REVISED STAFF REPORT AND RECOMMENDATION TO THE DESIGN COMMISSION

CASE FILE: LU 13-189059 DZM – Abigail Apartments
Pre-App.: EA 12-180268 PC
REVIEW BY: Design Commission
WHEN: **Thursday January 23, 2014 @ 1:30 pm**
WHERE: 1900 SW Fourth Ave., Room 2500A
Portland, OR 97201

C.17 Basement Plan

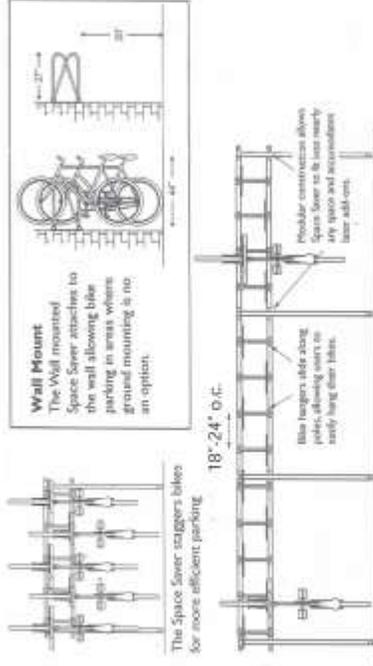
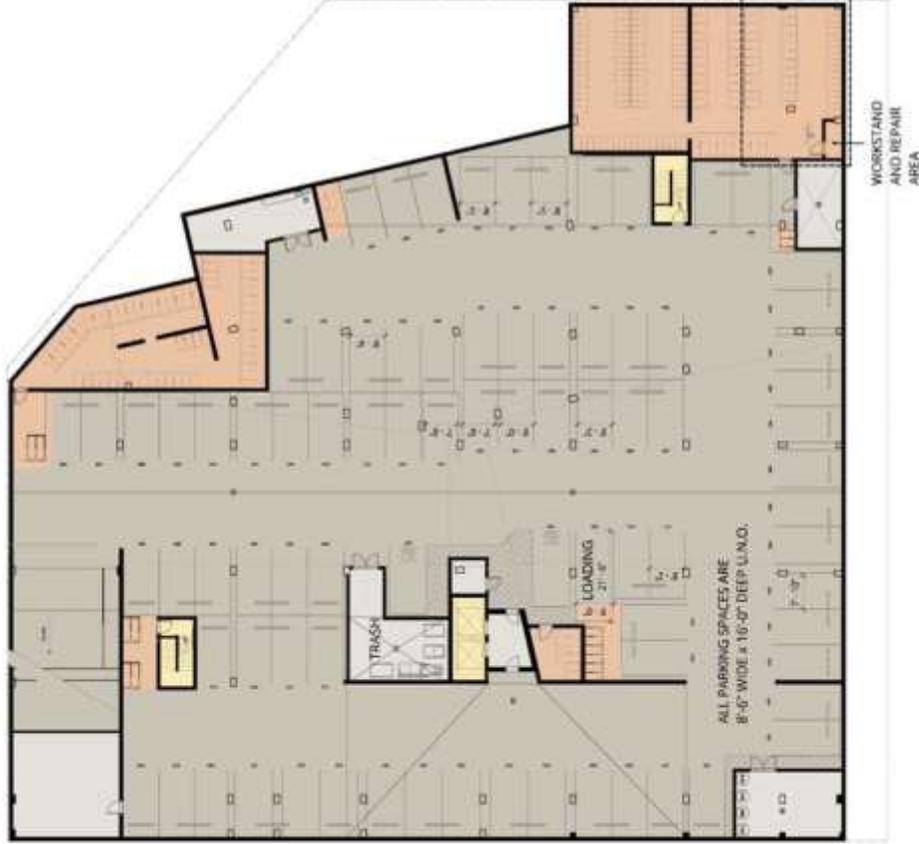
Modification #2 – Bike Parking Stall Width: Bike parking is provided in excess of the code requirement, and the applicant has revised the basement bike parking layout to reduce the number of reduced width stalls from 208 to 100. The wall-mounted staggered vertical rack system has a stagger and allowance for sliding hangers that will assist in the hanging and locking of bikes. Additionally, the loops to which the bike are hung project out of the wall 27" to further ease bike hanging. A 5'-0" aisle is still provided adjacent to each rack, and the Zoning Code does not yet establish a distinction between minimum dimensions for wall hanging spaces versus floor mounted spaces.

Approval of a Modification through Design Review to reduce the width of 100 (was 208) of the long-term bike parking stalls from 2’-0’ to 1’-6” (33.266.220.C.3).
